### **MFN 16-001, Revision 1**

### **ABWR COPS Redesign - ABWR DCD Revision 5 Markups**

Figure 19E.2-25 Limiting Configuration for COPS Blowdown Study

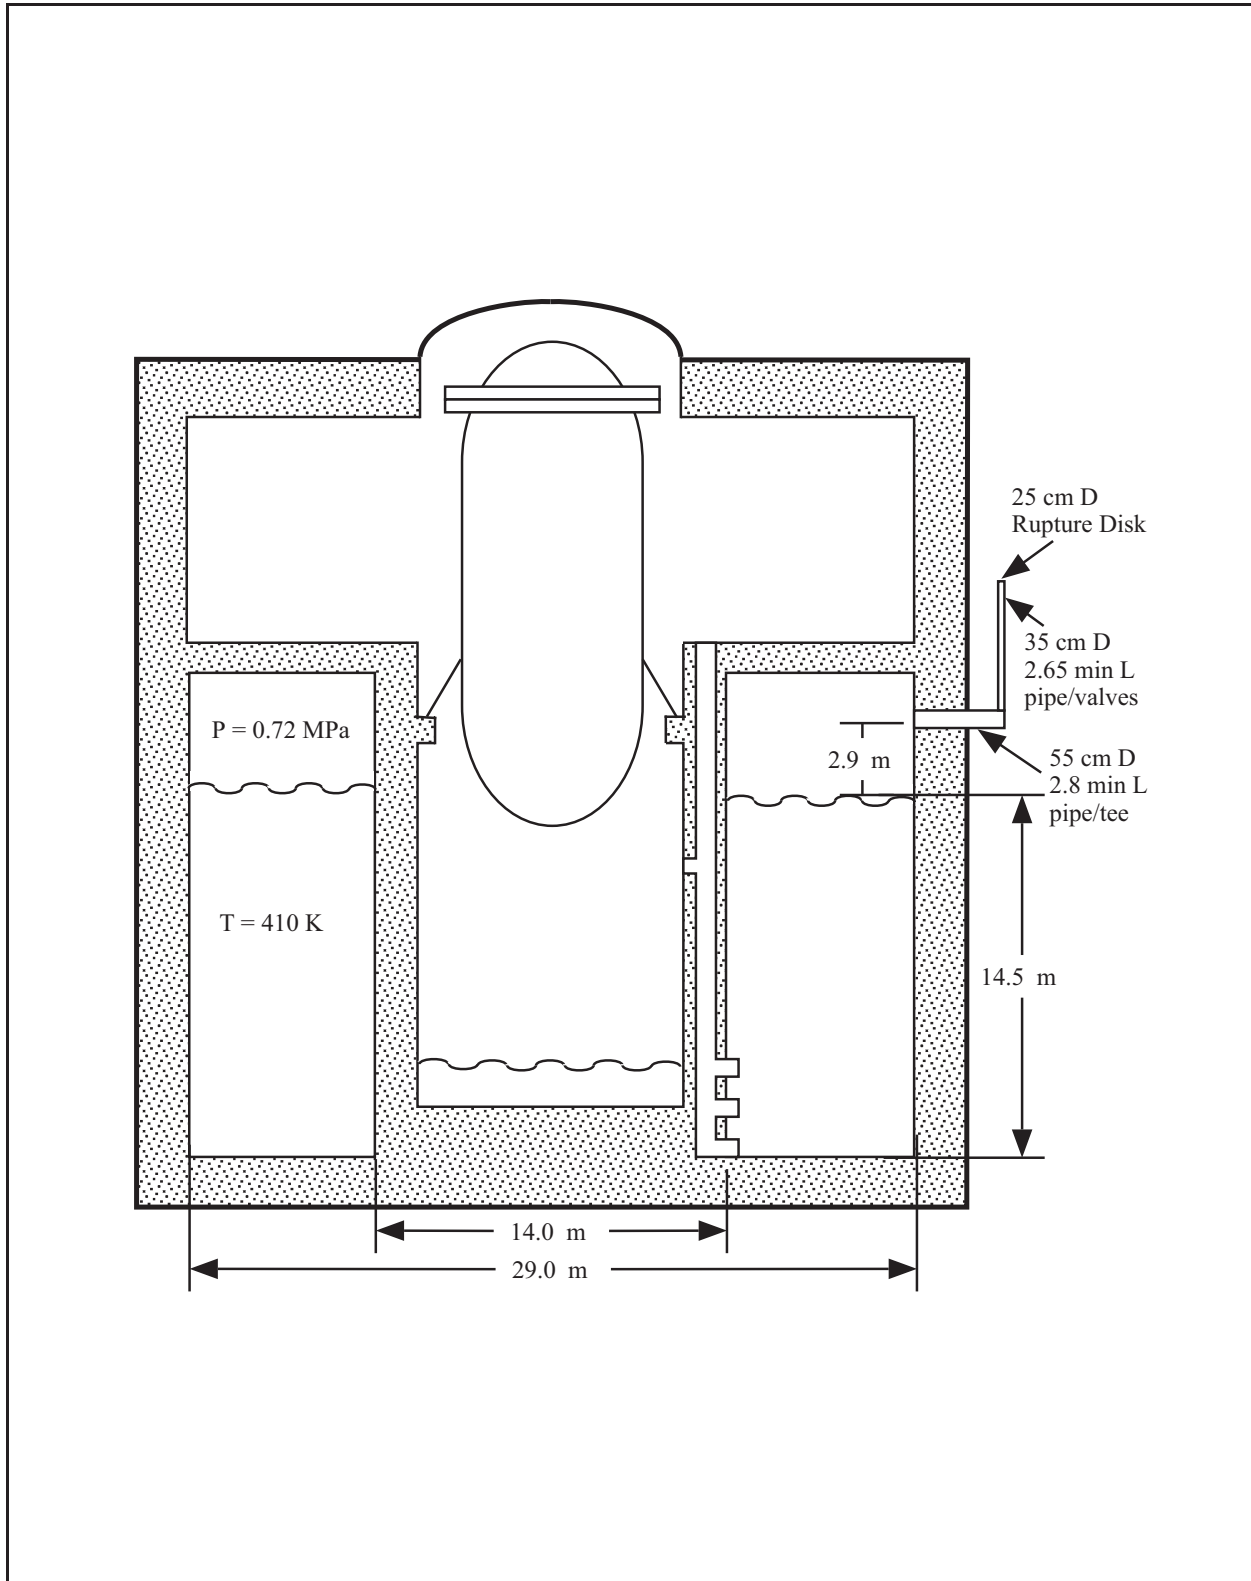
It was found that the originating decompression wave entering the containment airspace was ~~38.861.4~~ kPa, dropping below the initial 721 kPa air pressure. The decompression wave leaving the COPS pipe of 0.275 m (0.9 ft) radius would reach the pool surface a distance of 4 m (13.12 ft) away, attenuating from ~~38.861.4~~ kPa to ~~2.674.2~~ kPa. Since sound speed and density of water are much higher than corresponding values in air, a decompression wave entering the water is nearly twice that arriving in the air, or about ~~5.348.4~~ kPa. The decompression is not large enough to cause pool pressure to drop below its saturation pressure of 330 kPa at its initial temperature of 410 K, or 137°C (738 R or 278°F). The pool surface would move upward at only ~~0.0044 m/s (0.014 fps)~~ 0.0069 m/s (0.022 fps) for the transmitted decompression.

Acoustic theory can be applied if pressure disturbances do not create Mach numbers much greater than 0.2. An area ratio of  $a/A = 0.1320.207$  (diameter ratio of  $d/D = 0.3640.455$ ) with an airspace state described by

yields a gas velocity in the pipe of ~~31 m/s (102 fps)~~ 49 m/s (161 fps). The corresponding mach number is ~~31/406 = 0.076~~ 49/406 = 0.121, which justifies treating the decompression as an acoustic wave.

imaginary hemisphere of pipe radius  $R = D/2 = 0.55/2 \text{ m} = 0.275 \text{ m}$  (0.902 ft) has twice the pipe flow area, reducing the entrance velocity on the hemisphere to  ~~$31/2 = 15.5 \text{ m/s}$  (50.8 fps)~~ $49/2 = 24.5 \text{ m/s}$  (81 fps). The acoustic equation,

can be employed to show that the corresponding decompression disturbance is  $\delta P_0 = \del{38.8 \text{ kPa}} $61.4 \text{ kPa}$  (~~5.6 psid~~) $8.9 \text{ psid}$ ).$

If the water surface is a distance  $r = 4$  m away from the COPS pipe, the arriving decompression wave will have an amplitude of only ~~2.67~~4.2 kPa.

That is, the decompression wave arriving at the pool surface nearly doubles from the oncoming value to ~~5.34~~8.4 kPa. The plane wave analysis employed here is based on left and right traveling waves which add to satisfy continuity and energy conservation at the interface (Reference 19E.2-38). A similar analysis for spherical waves is obtained from the method of images to provide a plane surface of symmetry. The local pressure transmission and reflection amplitudes are the same as those obtained from the plane wave analysis (Reference 19E.2-38).

The ~~5.34~~8.4 kPa decompression wave transmitted into the water pool does not lower the initial 721 kPa pressure anywhere near the 330 kPa saturation pressure. Therefore, the arriving decompression cannot cause rapid pool flashing and swelling. Steam formation will occur in the pool later when continued decompression of the airspace lowers the pressure below saturation.

where subscript L refers to the water, and  $\delta P$  is the transmitted pressure disturbance. The resulting pool velocity is only ~~0.0044 m/s (0.014 fps)~~, 0.0069 m/s (0.022 fps).

FIGURE 6.2-39 ATMOSPHERIC CONTROL SYSTEM P&ID (Sheet 1 of 31)  
 ABWR DCD/Tier 2 Rev. 5 25A5675BC  
 21-220

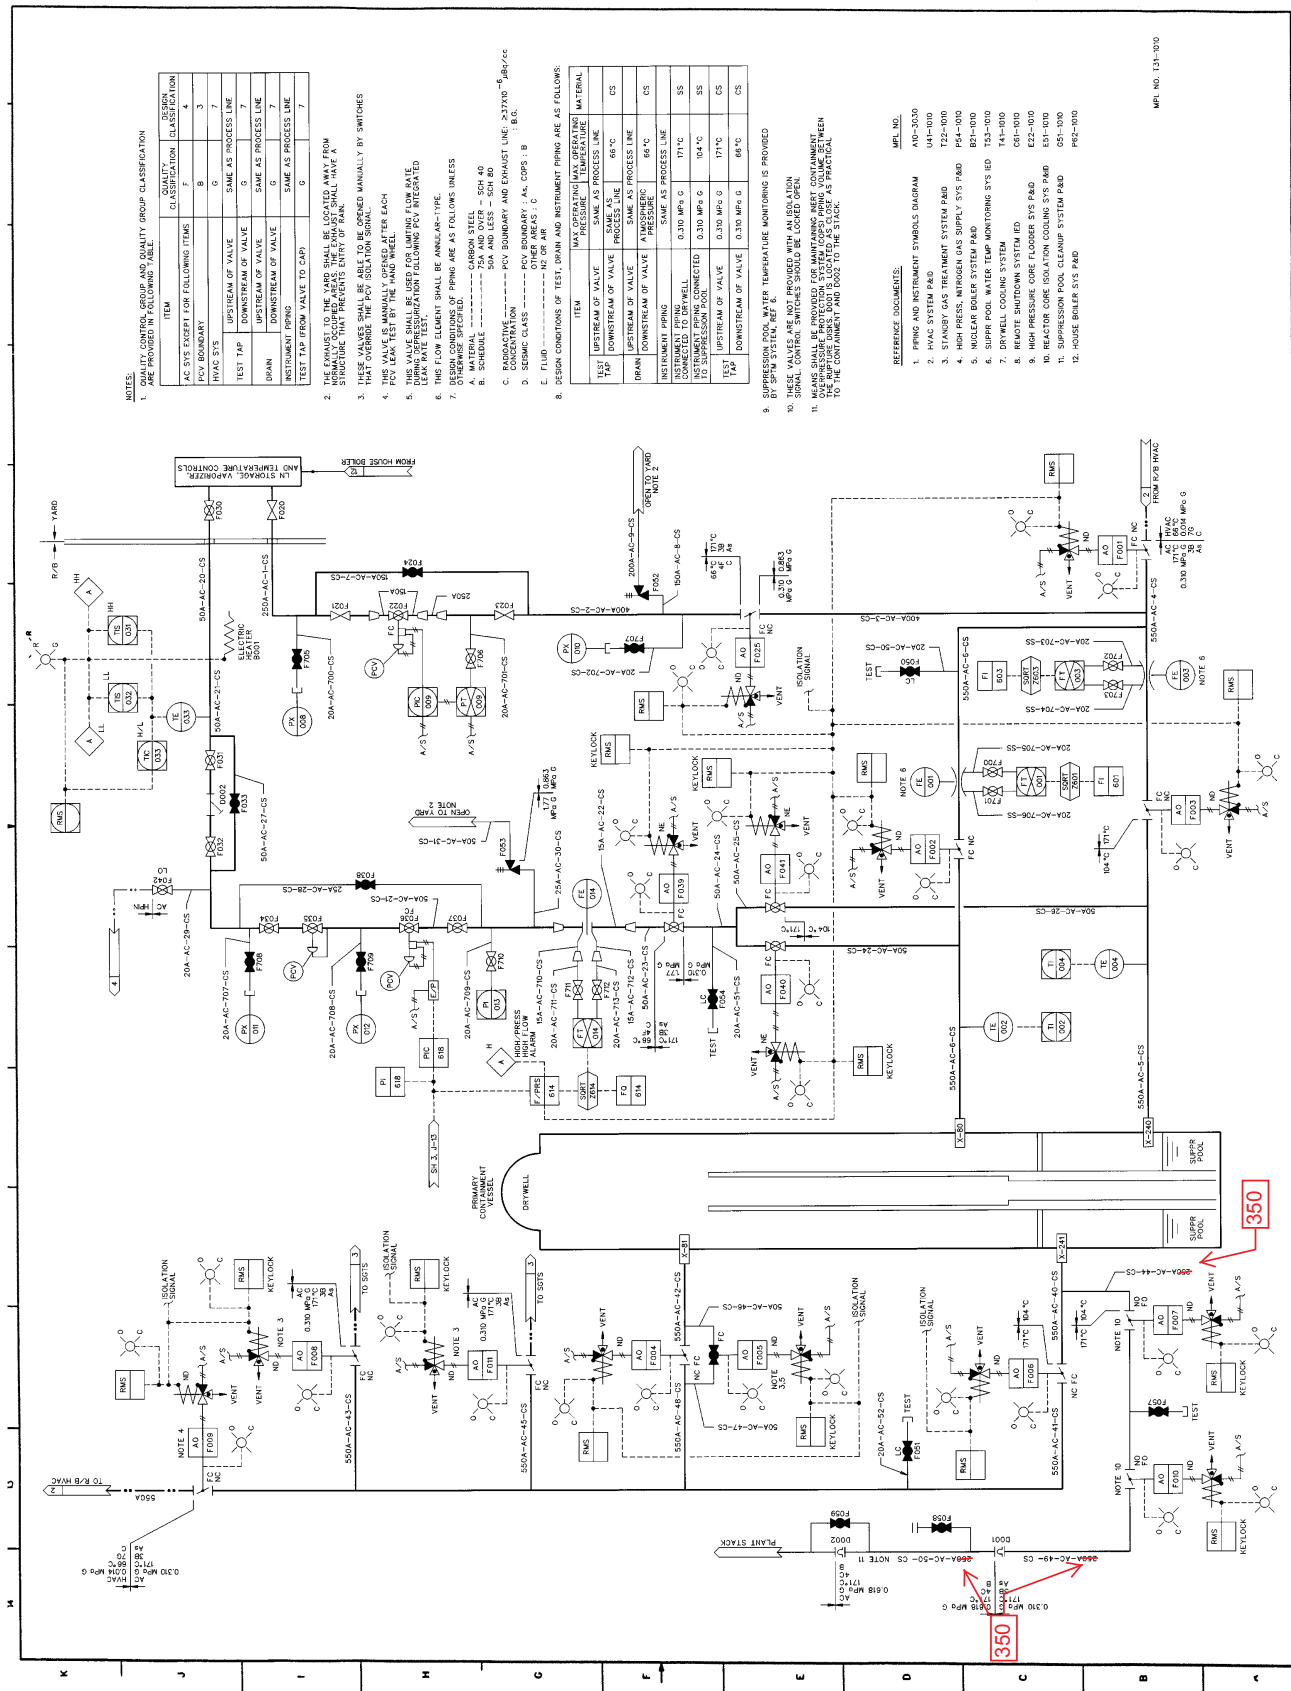
Valve No.	T31-F805A/B	T31-D001	T31-D002
Tier 2 Figure	6.2-39 (Sheet 3)	6.2-39 (Sheet 1)	6.2-39 (Sheet 1)
Applicable Basis	RG 1.11	GDC 56	GDC 56
Fluid	WW Atmosphere	WW Atmosphere	WW Atmosphere
Line Size	20A	<del>250A</del> 350A	<del>250A</del> 350A
ESF	No	Yes	Yes
Leakage Class	(a)	N/A	N/A
Location	O	O	O
Type C Leak Test	No(m)	No(P)	No (P)
Valve Type	Gate	Rupture Disk	Rupture Disk
Operator	Solenoid	Self	Self
Primary Actuation	Electric	N/A	N/A
Secondary Actuation	N/A	N/A	N/A
Normal Position	Open	Close	Close
Shutdown Position	Open	Close	Close
Post-Accident Position	Open	Open	Open
Power Fail Position	Open	N/A	N/A
Containment Isolation Signal <sup>(c)</sup>	RM	N/A	N/A
Closure Time (s)	N/A	N/A	N/A
Power Source (Div)	N/A	N/A	N/A
See page 6.2-167 for notes

The COPS is part of the atmospheric control system and consists of two ~~200A (8-inch)~~ 250A (10-inch) diameter overpressure relief rupture disks mounted in series on a ~~250A (10-inch)~~ 350A (14-inch) line which connects the wetwell airspace to the stack. The second rupture disk, located at the inlet to the plant stack, has a very low setpoint, less than 0.03 MPa differential pressure. The setpoint of the inner rupture disk, located near the containment boundary, will be selected such that the COPS opens when the wetwell pressure is 0.72 MPa. The COPS provides a fission product release point at a time prior to containment structural failure. Thus, the containment structure will not fail. By engineering the release point in the wetwell airspace, the escaping fission products are forced through the suppression pool. In a core damage event initiated by a transient in which the vessel does not fail, fission products are directed to the suppression pool via the SRVs, scrubbing any potential release. In a severe accident with core damage and vessel failure or in a LOCA which leads to core damage, the fission products will be directed from the vessel and drywell through the drywell connecting vents and into the suppression pool again ensuring any release is scrubbed. Eventually, if the containment pressure cannot be controlled, the rupture disk opens. Any fission product release to the environment is greatly reduced by the scrubbing provided by the suppression pool.
